## High-Pressure Hydraulic Hose Length Causing Intermittent Pressure Fault

Models Covered	Serial Number
Mercury QSD 2.8L Generation 1 Diesel Axius Products Mercury QSD 4.2L Generation 1 Diesel Axius Products	88401303–88408276

### Incorrect Hose

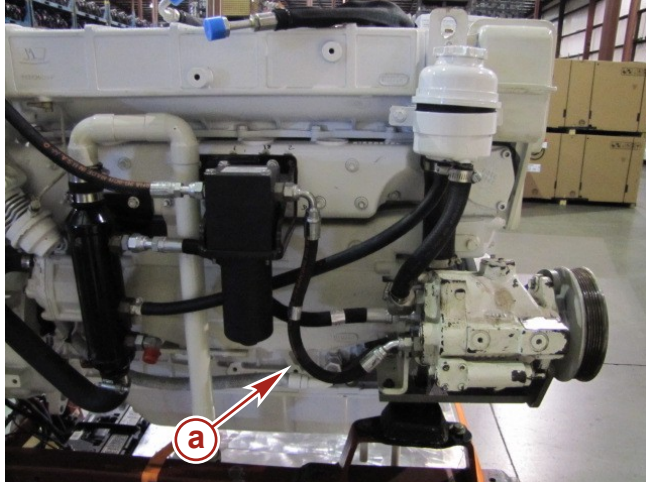
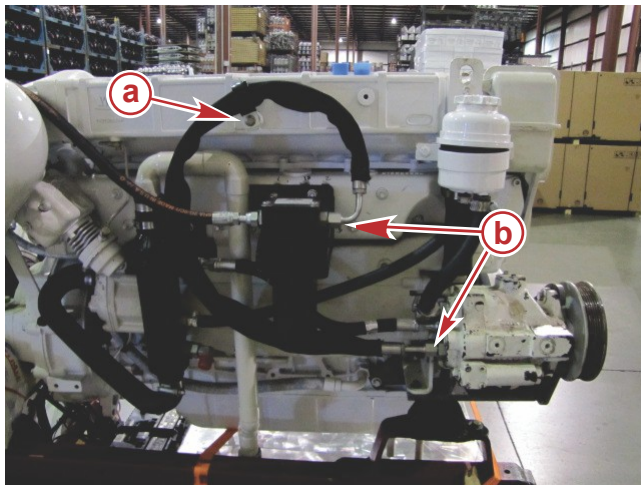
The power steering high-pressure hose, Mercury Marine part number 32-8M2019262, installed between the Axius power steering pump and the Axius high-pressure filter, can increase resonance in pump output pressure. This resonance may result in intermittent pump output pressure faults and alarms. The length of the hose is the primary cause of the resonance.

The high-pressure hose, part number 32-8M2019262 measures 38.1 cm (15 in.) end to end (seating surface to seating surface).

- a -** Requires part number 32-8M0065248 to be ordered and installed

The high-pressure hose contained in kit part number 32-8M0065248 measures 101.6 cm (40 in.) end to end.

Order and replace with high-pressure hose kit, part number 32-8M0065248.

- a -** Hose clamp and bolts
- b -** Hose swivel fittings

Description	Nm	lb-in.	lb-ft
Bolts (M8 x 12)	19	168	–
Hose swivel fittings	27	–	20
